AMENDMENT #2 TO INVITATION FOR BID: IFB# 2024-003 EV Charger Installation Project

FEDERAL AID NUMBER: CRP-5901(832)

DATE OF ISSUE: February 21, 2025

Figure 9: Map showing location of EV Charger installation in Short-Term Parking Lot.

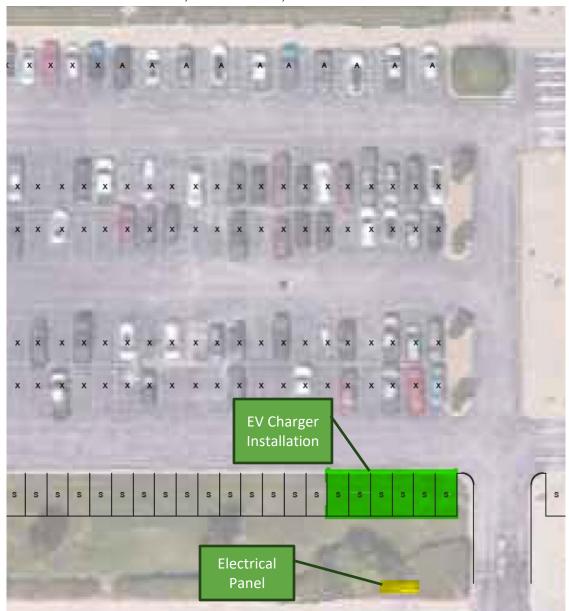
SGF SHORT-TERM PARKING LOT, SPRINGFIELD, MISSOURI

1. Description: This location consists of installation of three (3) Level 2 EV Charging Stations at the existing short-term parking lot located at the Roy Blunt Airline Terminal at the Springfield-Branson National Airport. This area will be under construction during the summer of 2025. Contractor will coordinate with the airport's contractor regarding site access and scheduling installation. Bid price shall include installation of electric vehicle charging equipment completed and in place, the concrete footing, connection to existing on site electrical system (including any required conduit, cables, cabinets, etc), any other required hardware, operations, maintenance and reporting for 5 years after installation.
